# ADDENDUM

ADDENDUM NO: 4

PROJECT: Hamilton Heights High School Phase 2 Projects

PROJECT NO: 2023060

DRAWING NUMBER  
E501

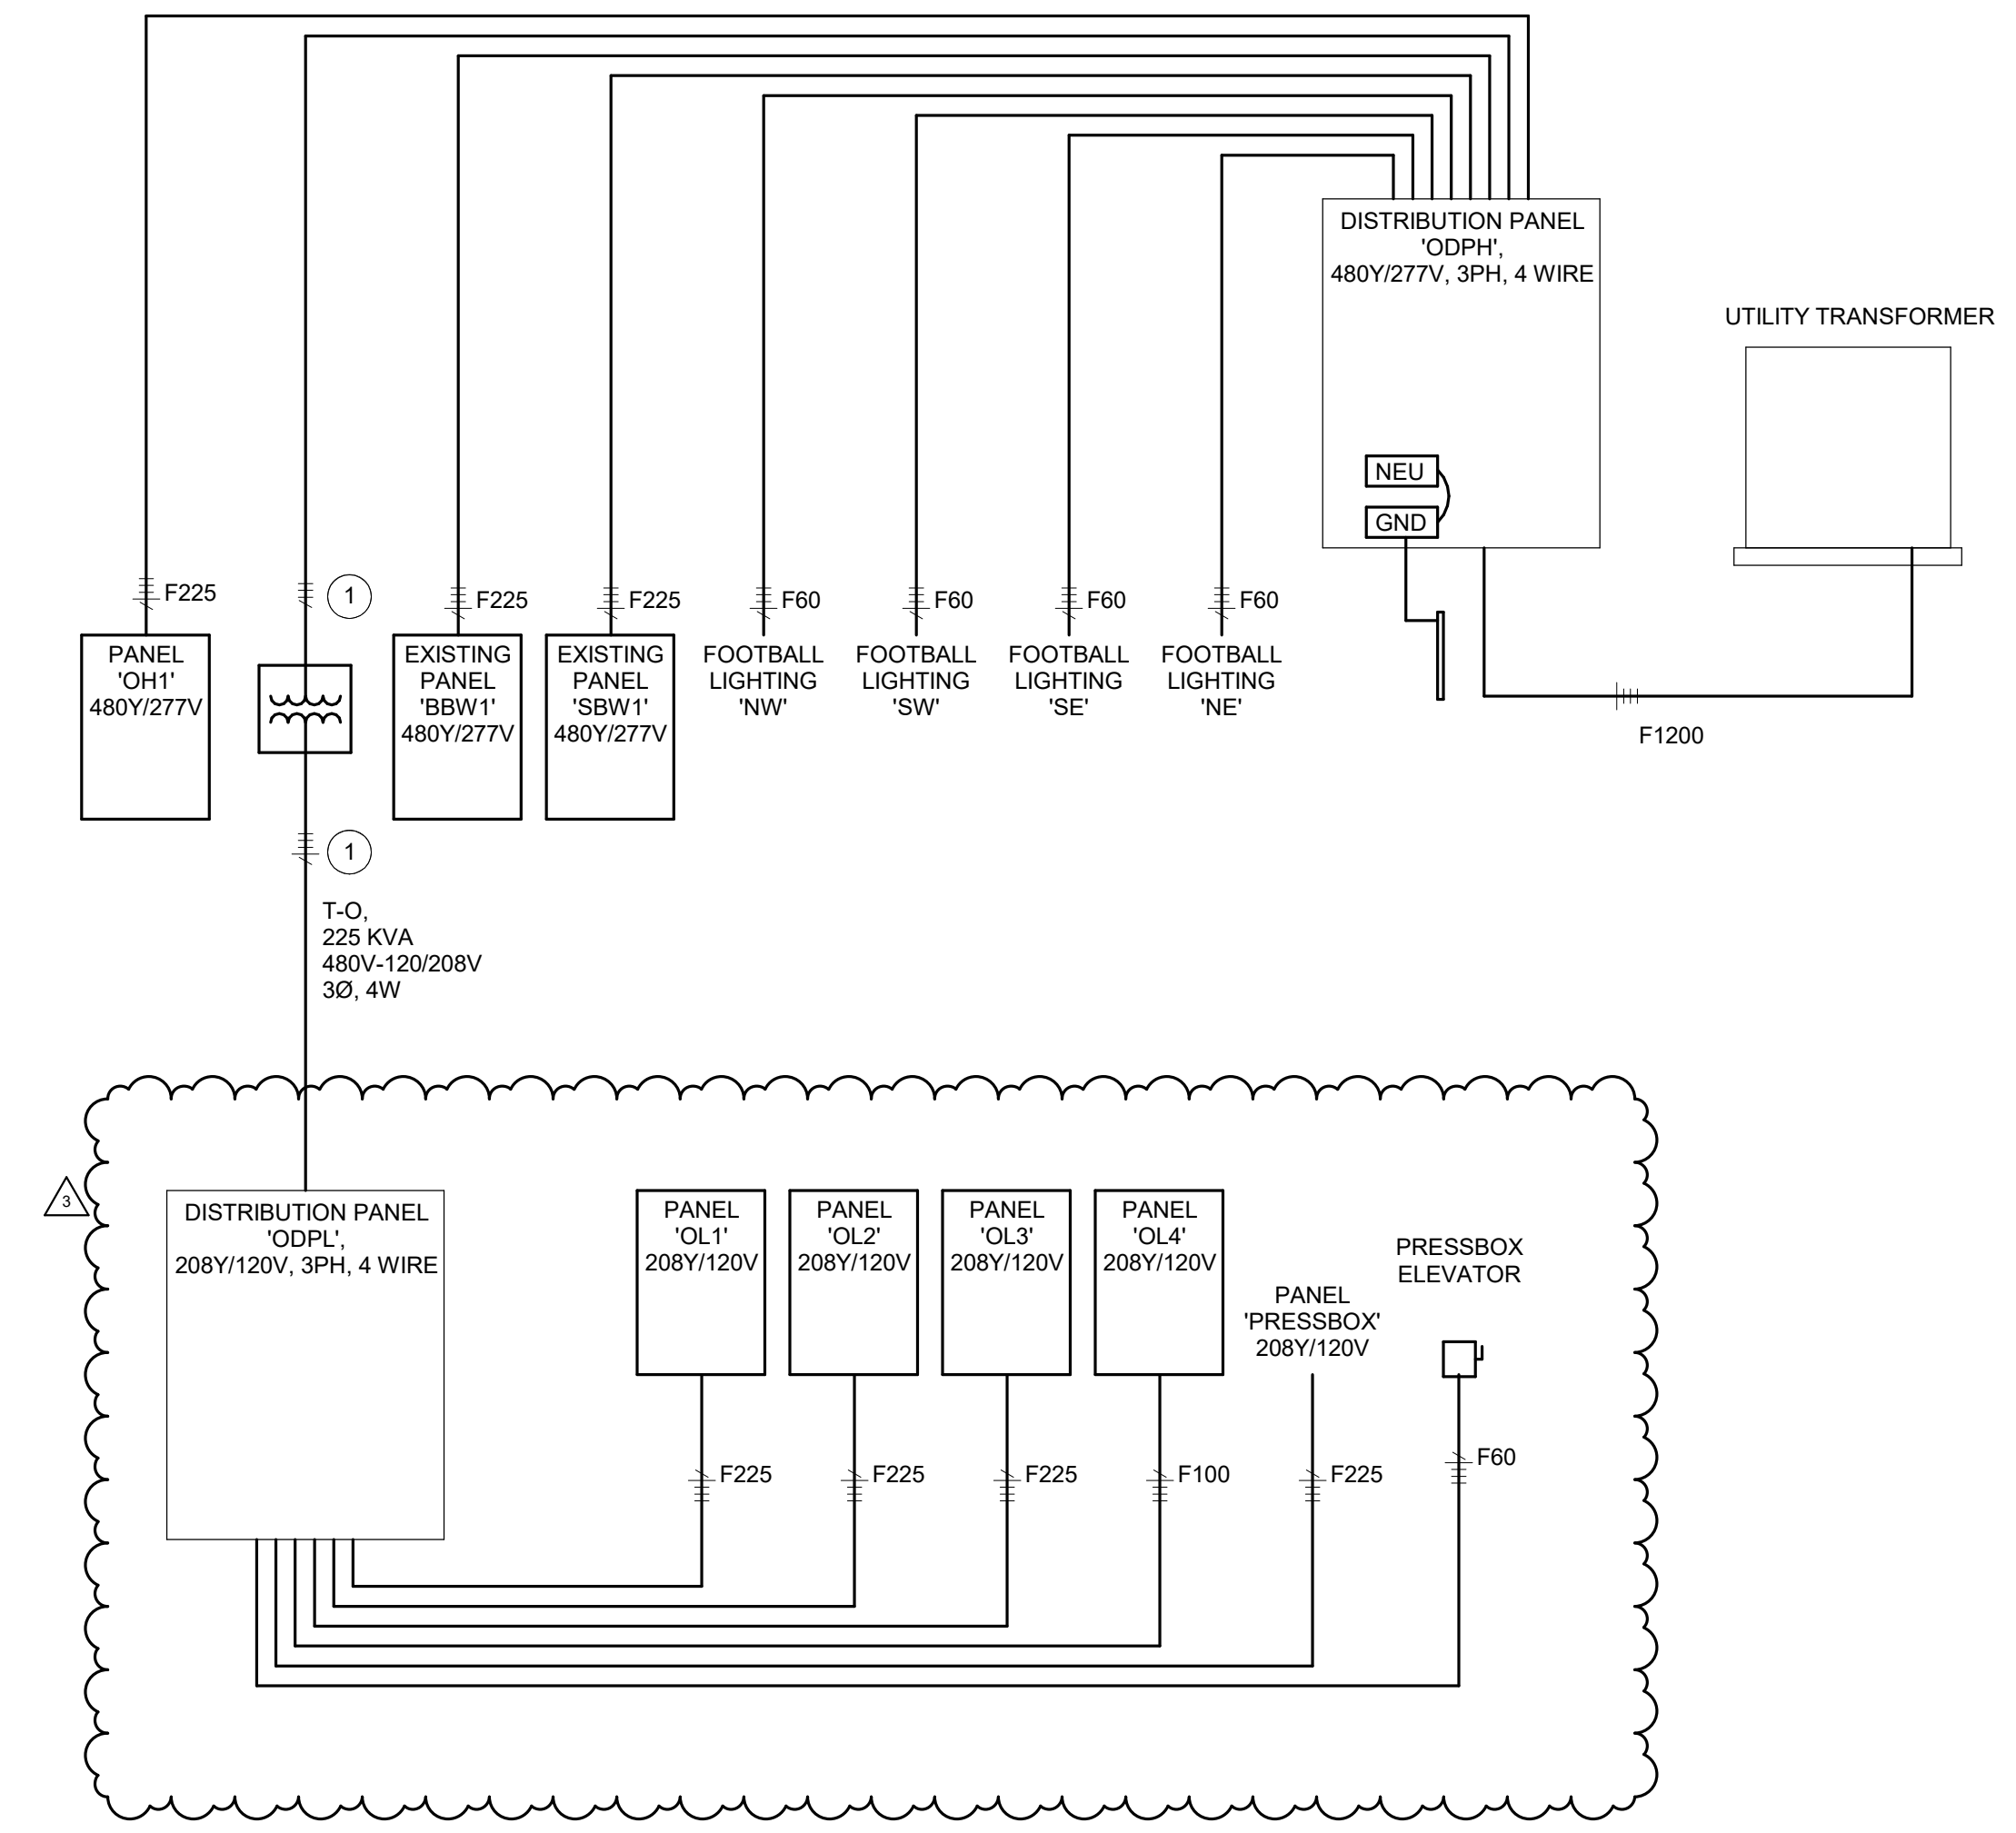
- A. Add Panelboard OL4.
- B. Reissue drawing in its entirety.
